DESIGN REVIEW COMMITTEE

June 18, 2025 6:00 PM

AGENDA

A-3

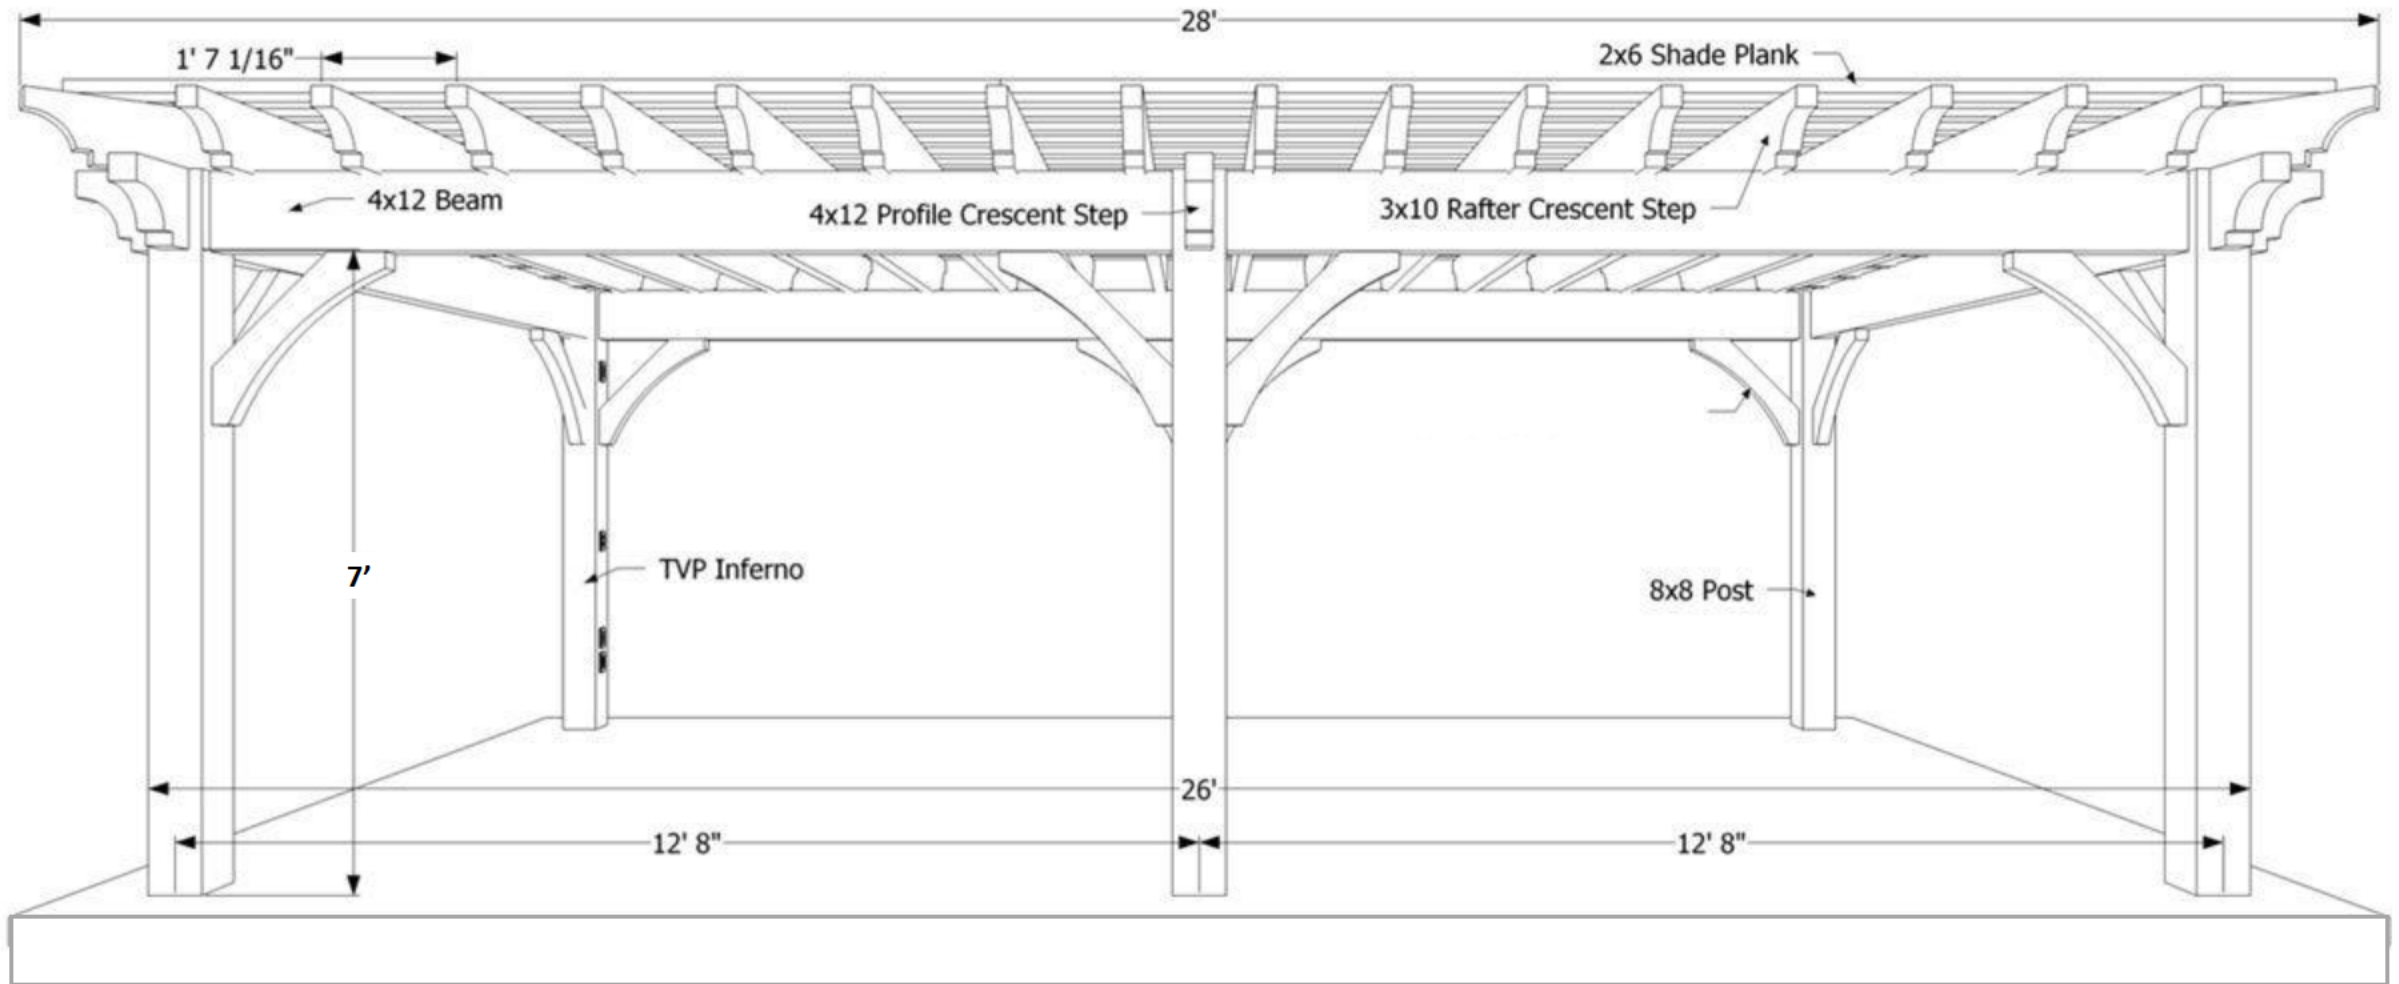
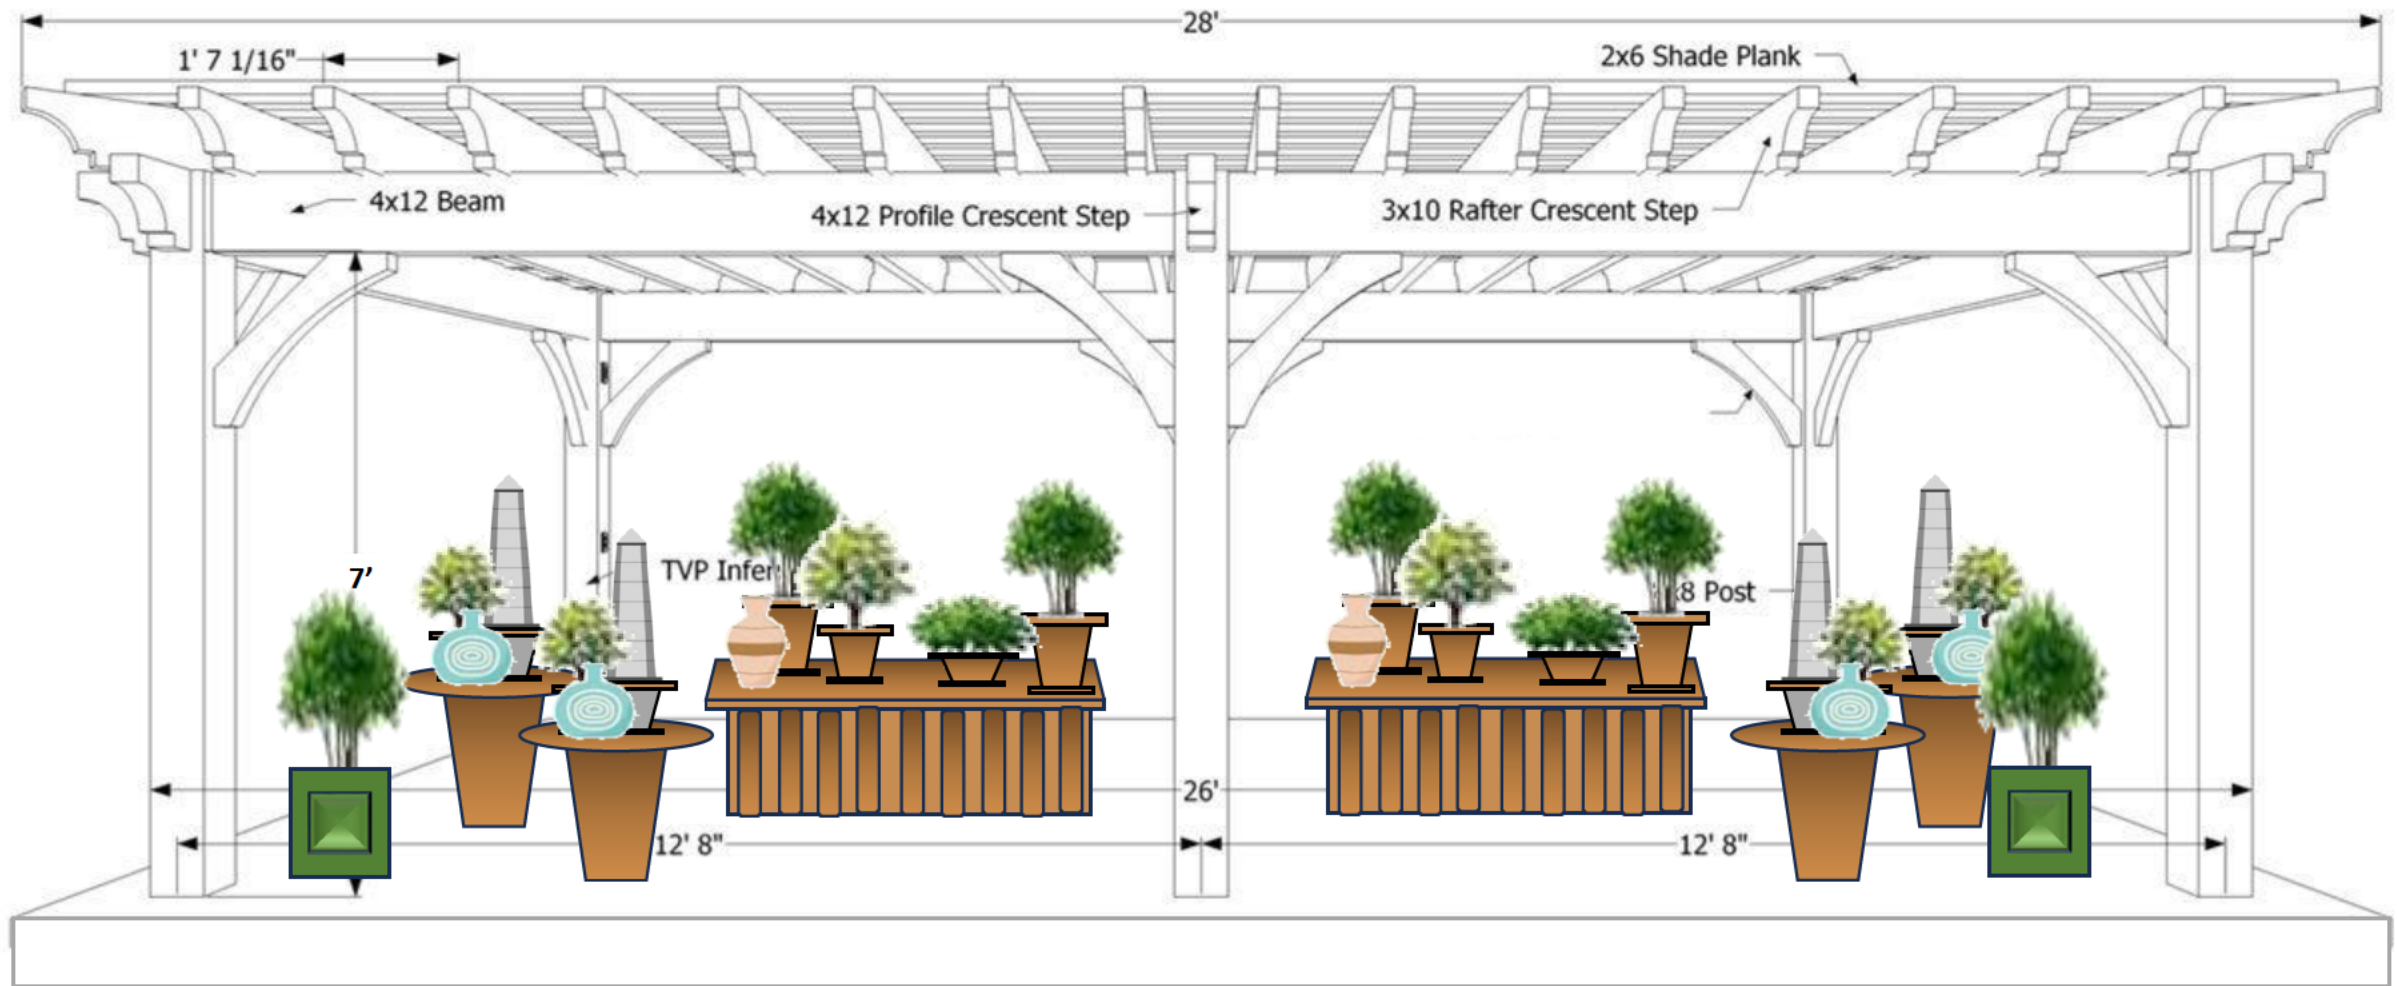
Please provide the distance between the pergola and any structures on adjacent lots.
